PLAN COMMISSION MEETING

Thursday – June 28 2018 – 7:00 p.m.

N168W20733 Main St

STAFF REVIEW COMMENTS
Plan Commission Meeting – June 22, 2018

CERTIFIED SURVEY MAP NO. _____

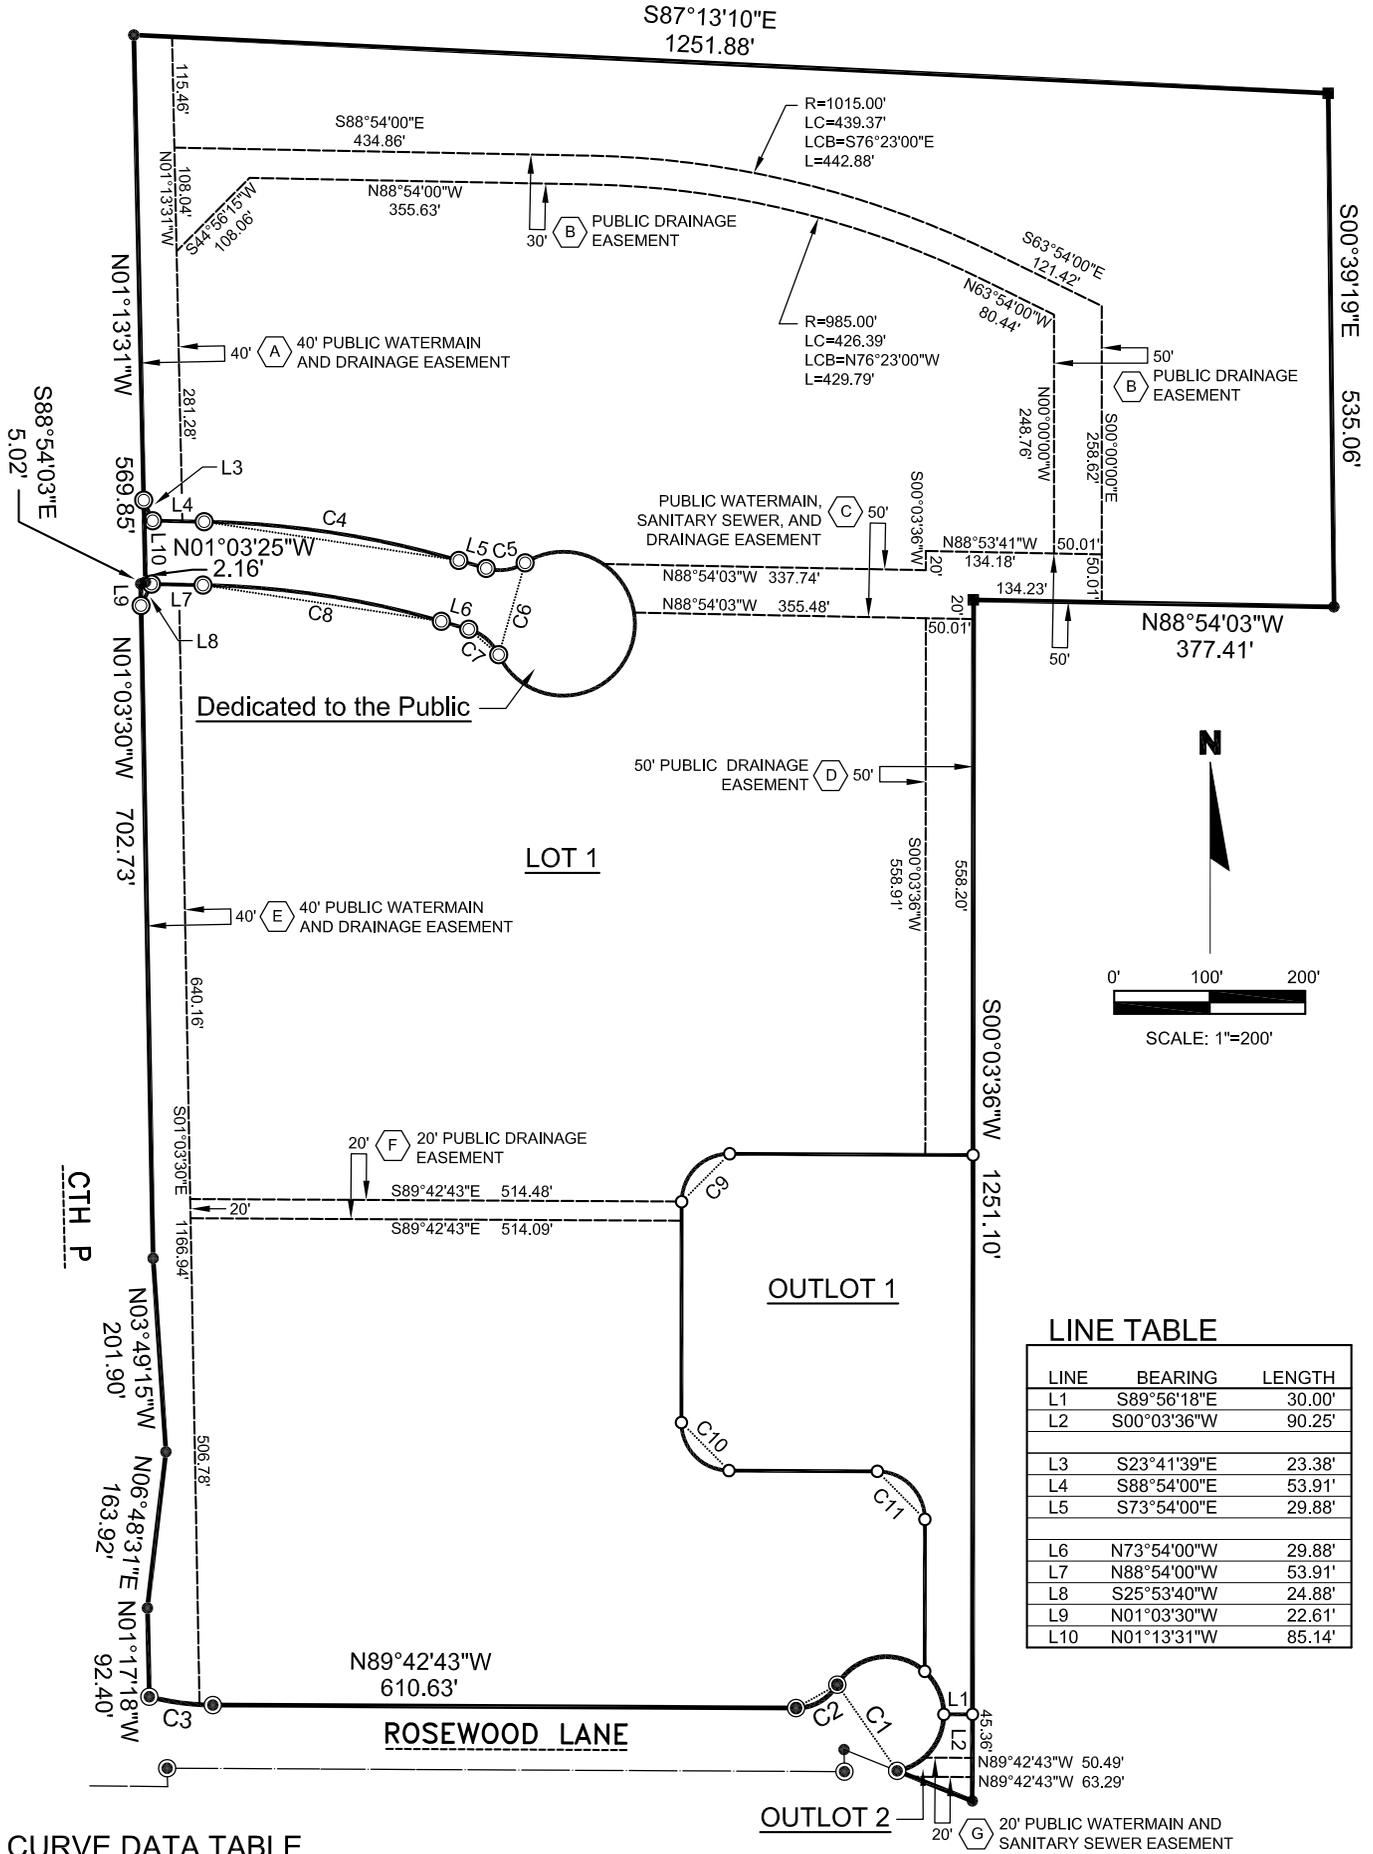
- The CSM has been modified to incorporate detention pond changes and storm sewer easements necessary for TIF #6 development. If Sylvester Court is to be renamed this would be a good time to do it. Recommend approval of the CSM.

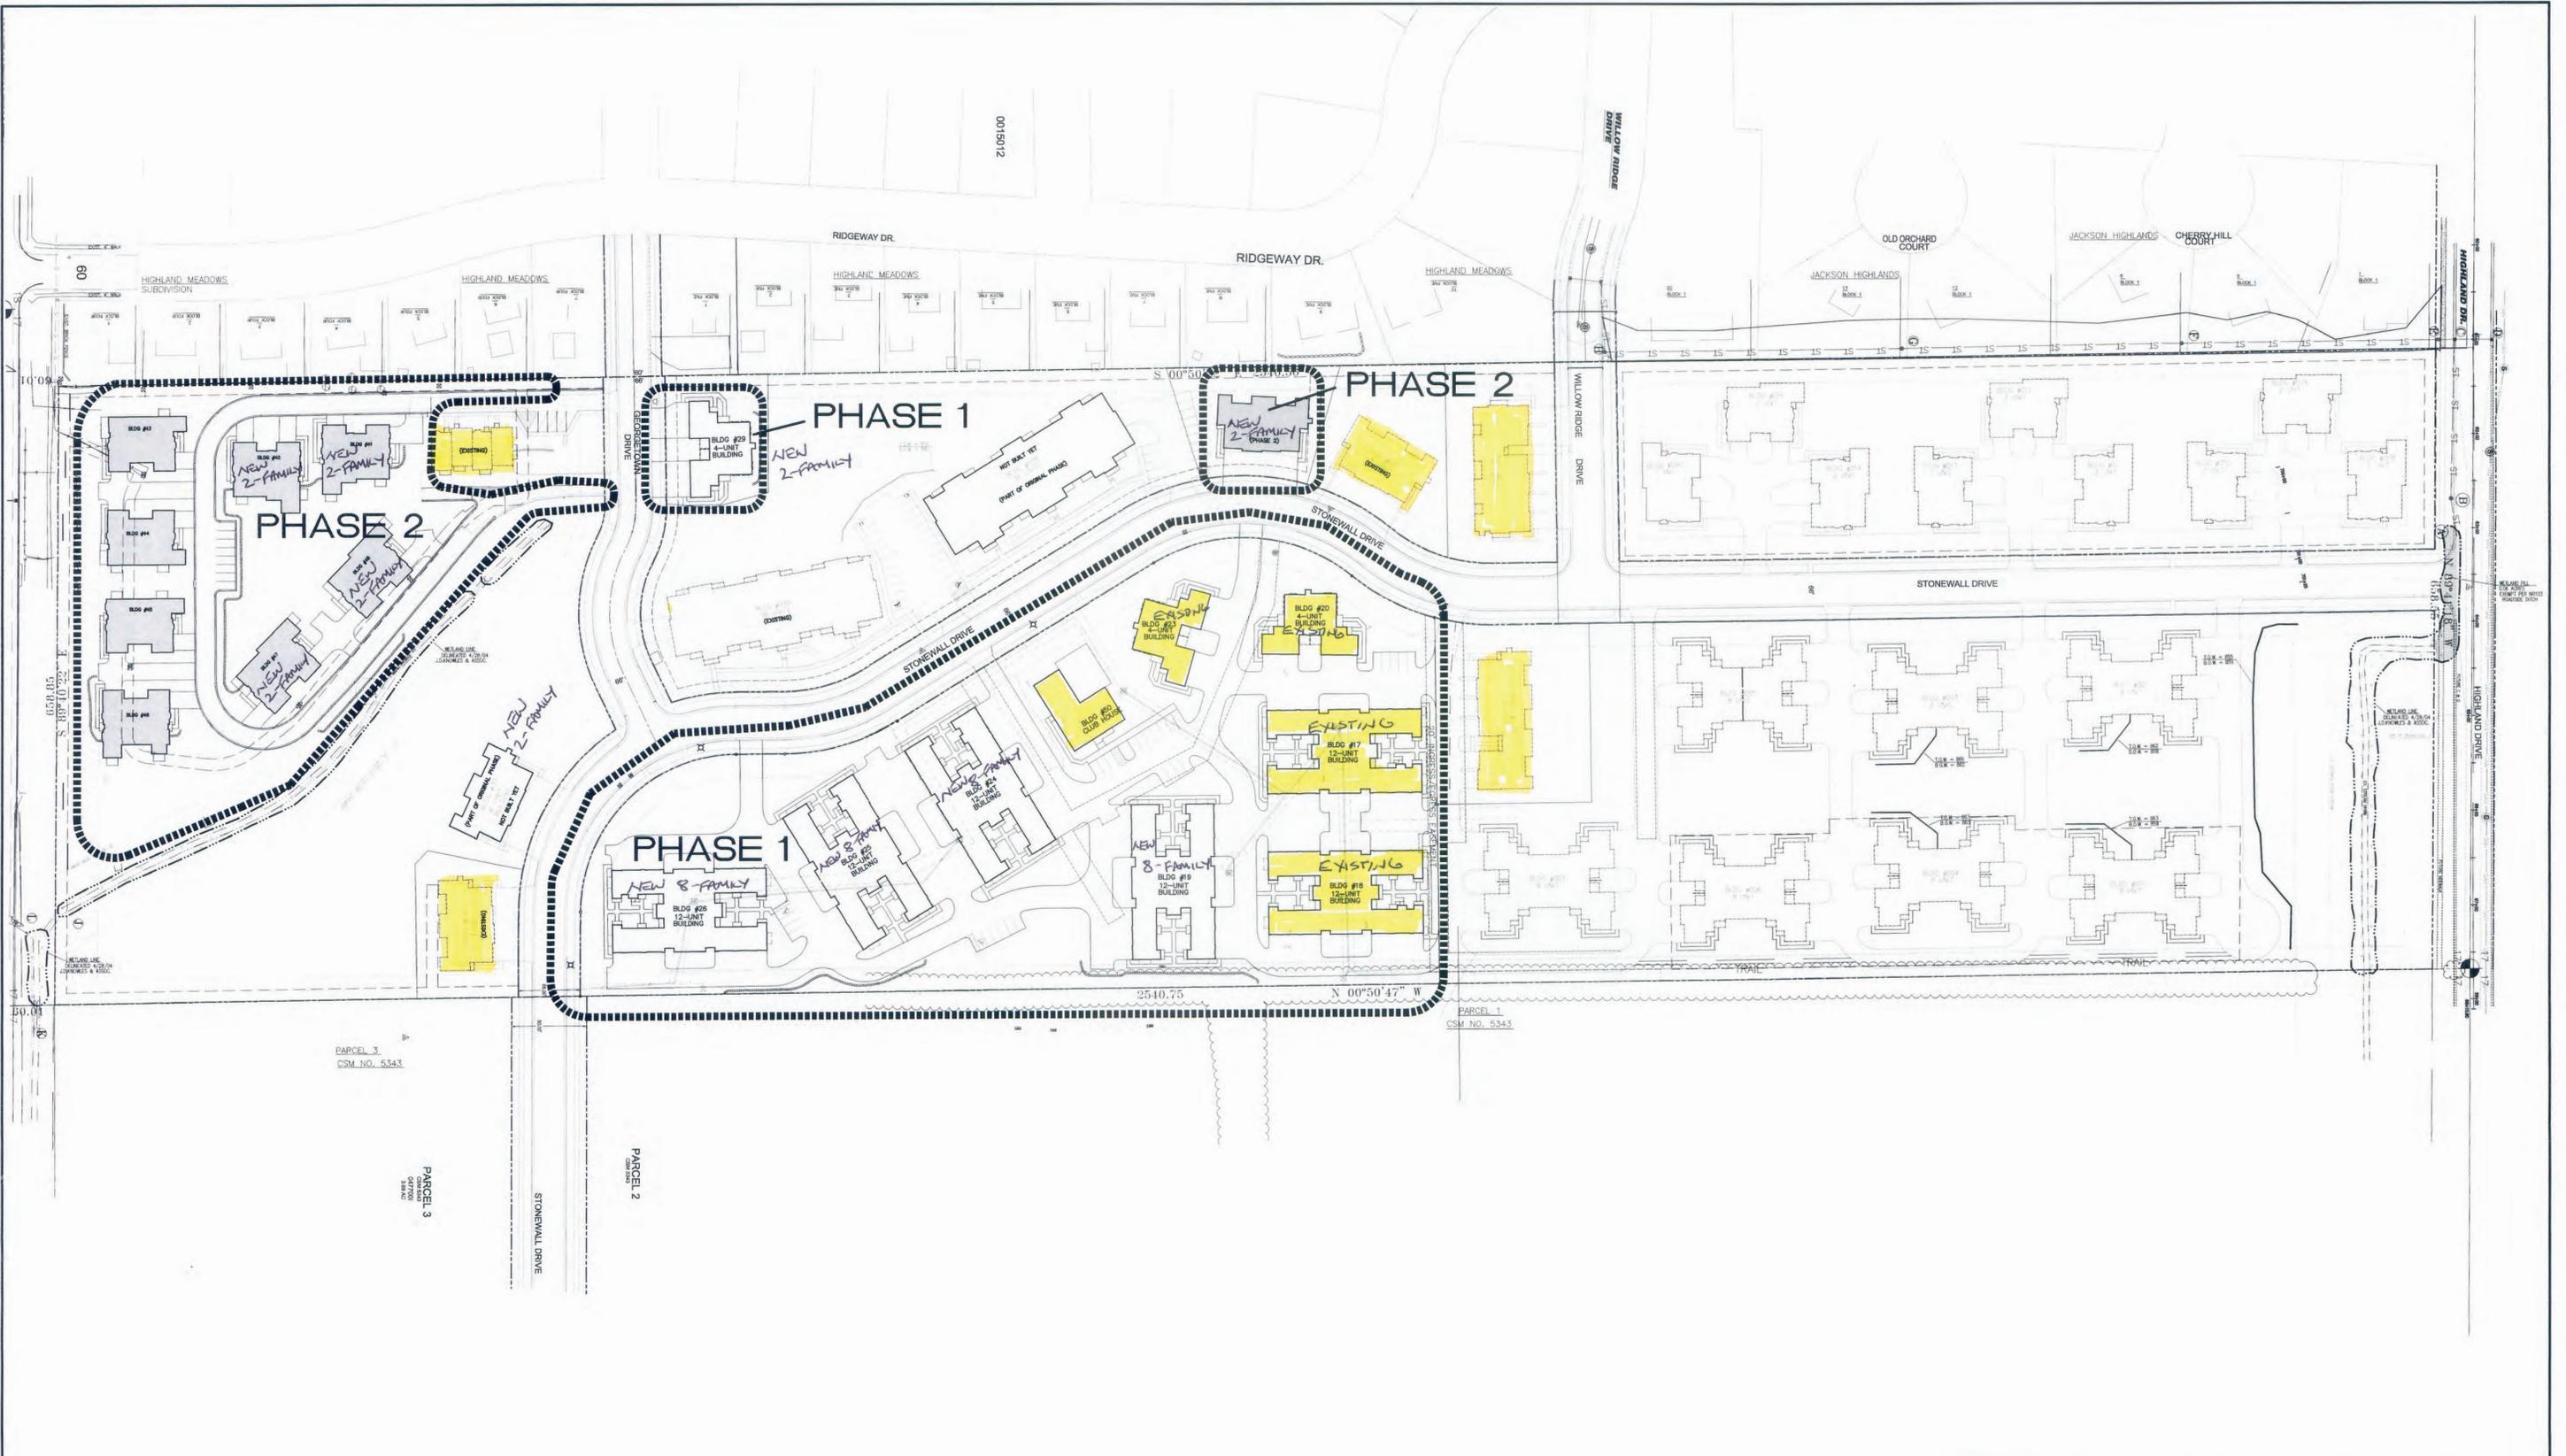
- This is coming back to the Plan Commission for review due the change of building types and due to the decrease in overall residential units
- Remaining building pads that were approved previously consisted of a total of 92 residential units. With this new layout the developer is proposing to reduce the total of remaining units to 46 (50% less) and the strip along Highway 60 to remain commercial use.
- Recommending have staff work with the developer to layout the inner area where the eight family buildings will be constructed for continuous flow through this area and connect with the existing internal private streets.
- Recommend approval
